Subject: Dominion Energy South Carolina, Inc.
Stevens Creek Hydroelectric Project
FERC Project No. 2535-129
Response to Additional Information Request dated November 25, 2024

RESPONSE TO ADDITIONAL INFORMATION REQUEST

FIGURE 1 STEVENS CREEK PROJECT DAILY GENERATION VERSUS FLASHBOARD STATUS

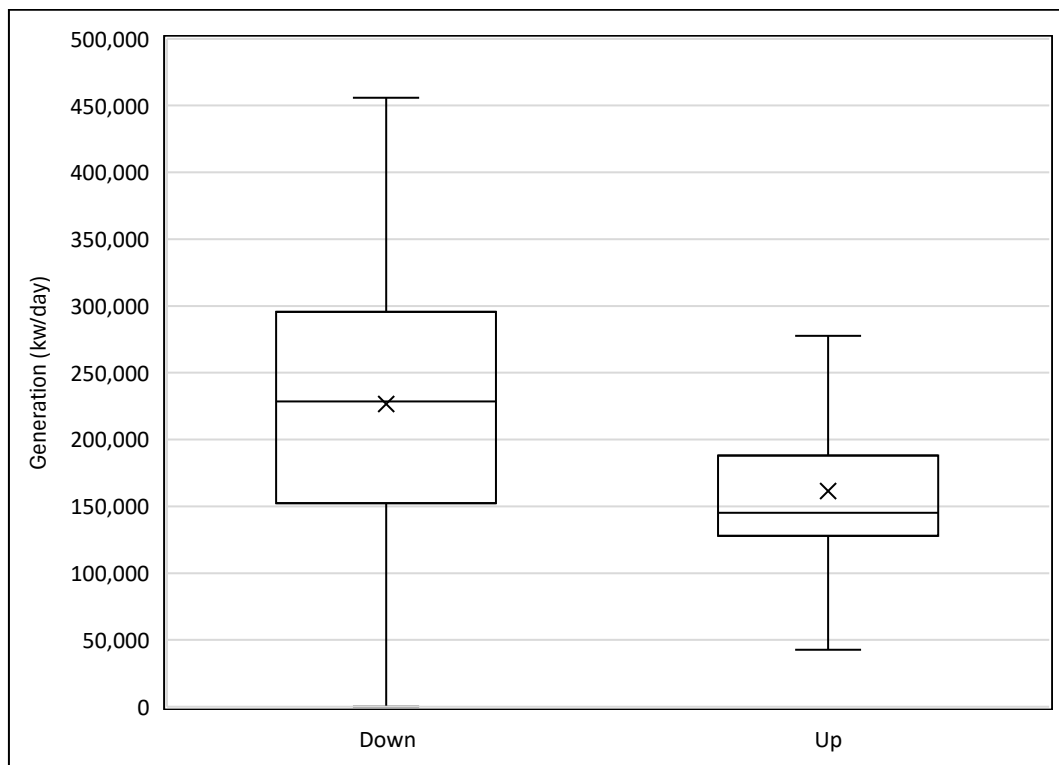
- (a) Provide an analysis that quantifies how often and to what degree flashboards-down affect the range of water level fluctuations downstream in the Savannah River; and**
- (b) Provide an analysis of the generation losses when flashboard-down conditions occur.**

- (b) The 1992 Engineering Analysis (Stone and Webster 1992) estimated a reduction in generation due to flashboard tripping of approximately 23 percent. The primary factor that would result in lost generation is reduced head. However, this is likely an overestimation of losses as many flashboard tripping events occur due to high river flows when head would not be reduced for a period of time. A more accurate estimation of generation losses would require a detailed and sophisticated modeling exercise at fine scale that appears outside the scope of this request. Generally, the Stevens Creek Project generates more electricity when the flashboards are tripped. DESC compared periods from 1998 to 2023 when both daily generation and flashboard status was available. Generation during periods when flashboards were down averaged 226,578 kilowatts (kWh) per day versus 161,469 kWh per day when flashboards were up – a difference of approximately 40 percent (Figure 1). As indicated, higher generation during flashboard tripped events is assumed to be due in large part to the higher flow availability and the gross head of the Stevens Creek Dam during the early part of the periods when the flashboards were down.
